UNITED STATES PATENT AND TRADEMARK OFFICE

APPLICATION NO.	FILING DATE	FIRST NAMED INVENTOR	ATTORNEY DOCKET NO.	CONFIRMATION NO.
10/792,040	03/03/2004	Sven Linow	10768-3US(P10225US)	4809

Quayle Action

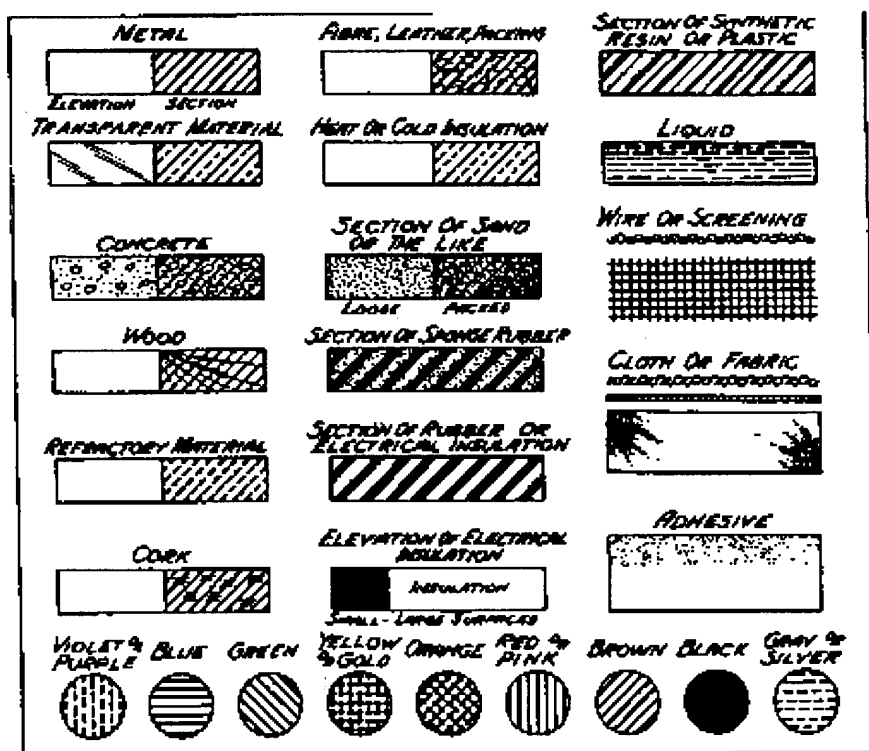
The drawings are objected to because of the following informalities:

Figs. 1A - 3A: Proper cross-sectional hatching is required to properly denote (1) transparent materials for cooling tube 3 (currently incorrectly hatched for metal), and (2) metallic hatching for reflector 8. Reflector 8 is currently hatched with darkened hatching which is improper. Hatching must be in accordance with MPEP 608.02 (see the drawing below for examples).

Corrected drawing sheets in compliance with 37 CFR 1.121(d) are required in reply to the Office action to avoid abandonment of the application. Any amended replacement drawing sheet should include all of the figures appearing on the immediate prior version of the sheet, even if only one figure is being amended. The figure or figure number of an amended drawing should not be labeled as "amended." If a drawing figure is to be canceled, the appropriate figure must be removed from the replacement sheet, and where necessary, the remaining figures must be renumbered and appropriate changes made to the brief description of the several views of the drawings for consistency. Additional replacement sheets may be necessary to show the renumbering of the remaining figures. The replacement sheet(s) should be labeled "Replacement Sheet" in the page header (as per 37 CFR 1.84(c)) so as not to obstruct any portion of
